EAST COUNTY SUBSTATION PROJECT

MINOR PROJECT REFINEMENT REQUEST FORM

Date Submitted:	05-17-13 (Originally Submitted) 06-12-13 (Resubmittal) 06-25-13 (Resubmittal)	Request #:	4	
Date Approval Required:	06-28-13	Landowner:]Vj ku'lphto cvkqp'j cu'dggp" tgf cevgf 'f wg'vq'ku'eqphk' gpvkn' pcwtg_"	
APN:]Vj ku'lphto cvkqp'j cu'dggp'tgf cevgf 'f wg'vq'ku'eqphk' gpvkn'pcwtg_			
Refinement from (check all that apply):				
<input type="checkbox"/> Mitigation Measure	<input type="checkbox"/> APM	<input checked="" type="checkbox"/> Project Description	<input type="checkbox"/> Drawing	<input type="checkbox"/> Other
Identify source (mitigation measure, project description, etc.):				
<p>Page C-26 and Figure C-4B in Section C. Alternatives of the Final Environmental Impact Report/Environmental Impact Statement (EIR/EIS) for the East County (ECO) Substation Project (Project) describe and depict the alignment of the main access road to be constructed from Old Highway 80 southeast to the ECO Substation, which is now referred to as the Southern Access Road. Figure C-4B of the Final EIR/EIS depicts the 138 kilovolt (kV) Overhead Transmission Line between the ECO Substation and Old Highway 80, which

SIGHT DISTANCE STUDY - FINAL

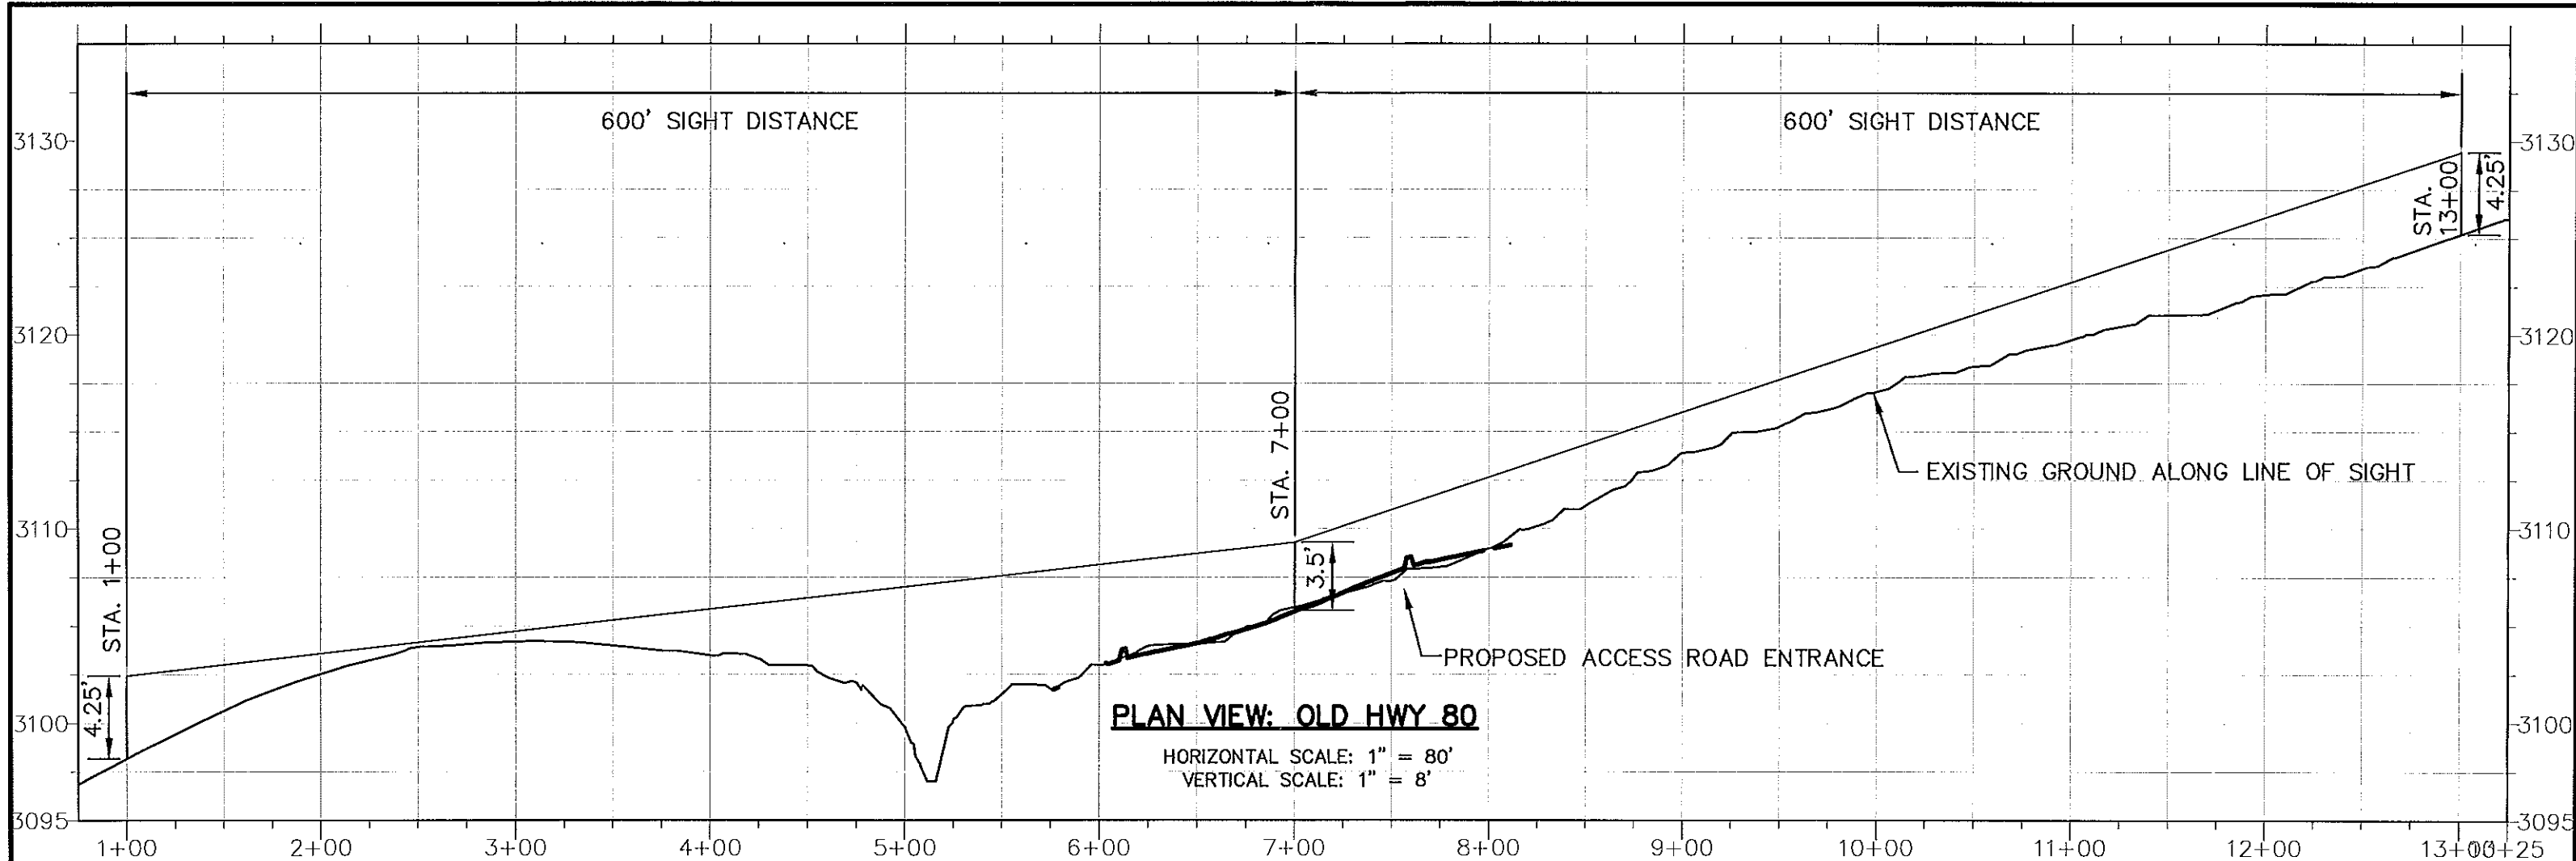
SDG&E submitted copies of the ECO Substation construction plans to San Diego County for review on September 13, 2012. On October 9, 2012, San Diego County requested that an engineer certify that the sight distance would be unobstructed from both directions at the entrance to the Southern Access Road based upon the prevailing operating traffic speed on Old Highway 80, per the Design Standards of Section 6.1.E of the San Diego County Public Road Standards (March 2012). The originally proposed entrance was determined based upon the posted speed limit on Old Highway 80, which is 55 miles per hour. During consultation with San Diego County, SDG&E was advised that the prevailing operating traffic speed on Old Highway 80 is approximately 60 miles per hour. San Diego County Public Road Standards require a minimum corner intersection sight distance of 600 feet for a design speed of 60 miles per hour. SDG&E determined that the originally approved entrance to the Southern Access Road would only provide approximately 523 feet of sight distance in one direction and would not meet San Diego County line-of-sight distance requirements associated with safe entrance onto public roadways. In order to comply with San Diego County Public Road Standards, SDG&E recalculated the location of the entrance and shifted it approximately 70 feet to the northeast to provide the required sight distance and safe access onto the public road. SDG&E then submitted a sight distance letter and exhibit to San Diego County on November 13, 2012, demonstrating compliance with the line-of-sight requirements. Documentation of correspondence with the county, as well as construction plans demonstrating compliance with line-of-sight requirements, is provided as Attachment G: County Correspondence and Line-of-Sight Documentation.

7. A Registered Civil Engineer, Registered Traffic Engineer, or Licensed Land Surveyor shall provide a certified signed statement that, "Physically, there is a minimum unobstructed sight distance in both directions along Old Highway 80 from the private access road serving the substation, for the prevailing operating traffic speed on Old Highway 80 per the Design Standards of Section 6.1.E of the County of San Diego Public Road Standards (dated March 2012), to the satisfaction of the Director of Public Works. If the lines of sight fall within the existing public road right-of-way, the engineer or surveyor shall further certify that, "Said lines of sight fall within the existing right-of-way and a clear space easement is not required."
